Site Control Modification Manual 14H Update

November 2024
Planning Committee

Jonathan Thompson
Interconnection Projects

Exhibit 10: Generator Interconnection into Existing TO Substation

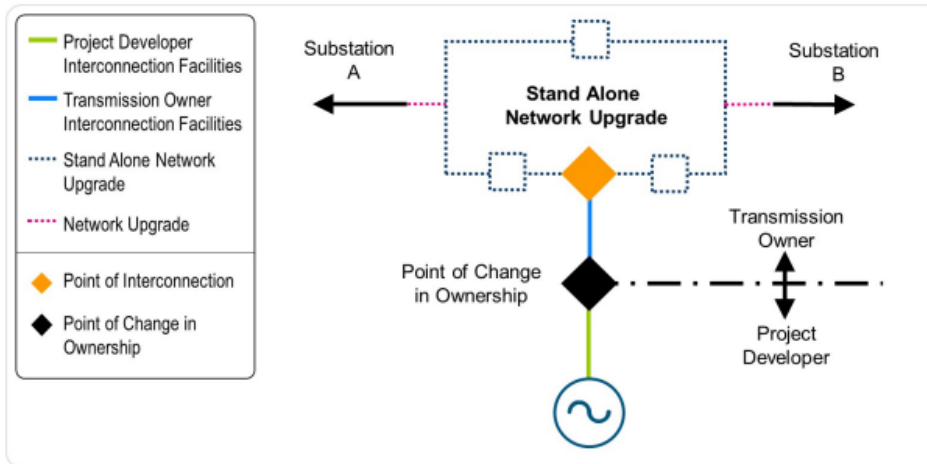
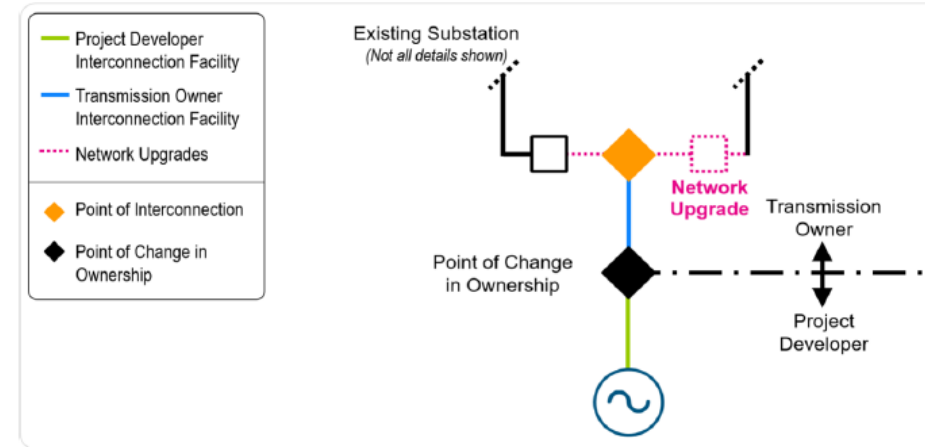
- In M-14H Section 4.9 shows diagrams of typical New Service Request Connection Types
- Exhibit 9 shows “Generator Interconnection via New Interconnection Switchyard”
- Exhibit 10 is supposed to show “Generator Interconnection into Existing TO Substation” but instead is the same diagram used in Exhibit 9

- PJM seeks to correct Exhibit 10
- PJM seeks to provide greater clarification on how Developers can meet tariff requirements for Site Control and what Site modifications are allowed under the tariff
- As PJM continues progress through TC1 and TC2 applications are due in Q4 2024, it is important for Developers to understand what Site Control modifications are allowed under the tariff in order to be able to continue to develop their projects and meet tariff requirements for Site Control at various points of the Interconnection Cycle process

4.9.2 Generator Interconnection into Existing Transmission Owner's Substation
 Exhibit (Generator Interconnection into Existing TO Substation) depicts a generator interconnecting to an existing Transmission Owner substation which needs to be expanded to accommodate the interconnection.
